# 1984 - 1985 Corvette: Service Bulletin: Noise in Direct Drive 4-Speed Manual Transmission

**Bulletin No:** 85-111

**Figure 1**

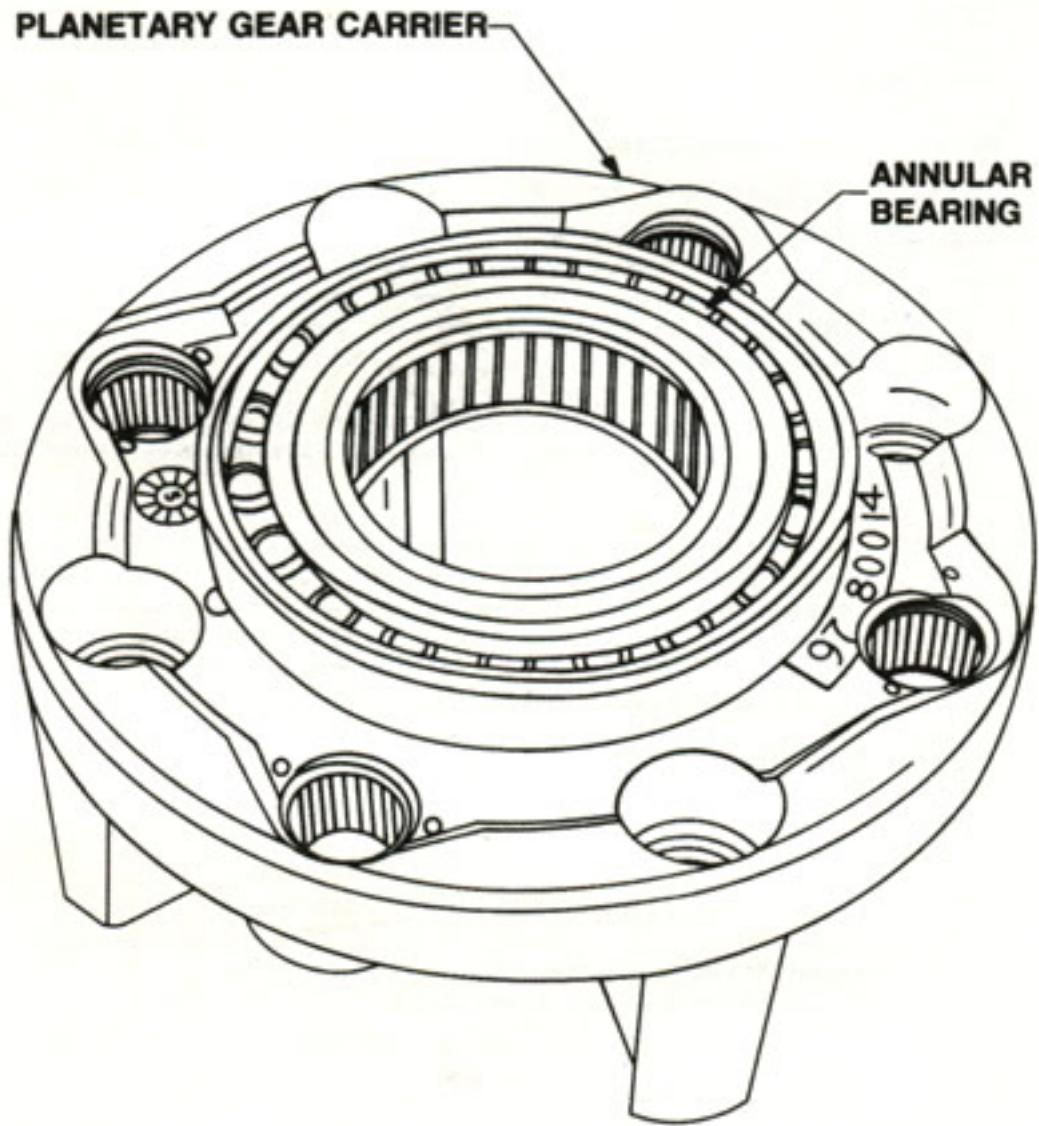
This condition may be caused by a worn annular bearing on the planetary gear carrier (see illustration). Continued operation of a noisy transmission in the direct drive model will cause damage to the planetary carrier, adapter plate, input sun gear, and input sun gear oil seal. If the input sun gear oil seal is damaged, it is possible for overdrive unit oil (Dexron II) to leak into the manual portion of the transmission.

On transmissions beginning with serial number D5C 14413 CF, a new planetary gear carrier has been released. This carrier (P/N 14094571) incorporates an annual bearing with increased thrust capacity.

1. Inspect the adapter plate surface, input sun gear, and input sun gear oil seal for damage. If there is indication of damage, the adapter plate, input sun gear, and input sun gear oil seal should be replaced. If there is no sign of damage, these parts may be reused.
2. If debris is present in the overdrive unit, completely disassemble and clean the unit, including the valve body. Thoroughly flush the cooler lines to remove any debris following the procedure outlined in the Vehicle Service Manual. Replace the oil filter.
3. If there is evidence of oil intrusion from the automatic overdrive unit into the 4-speed manual unit, the manual unit should be drained and flushed also.
4. Replace the planetary gear carrier with the new, P/N 14094571, carrier.

**NOTICE:** When an overdrive unit from a transmission built prior to serial number D5C 14413 CF is disassembled for any reason, it is recommended that a new, P/N 14094571, planetary gear carrier be installed to prevent potential future annular bearing failures.
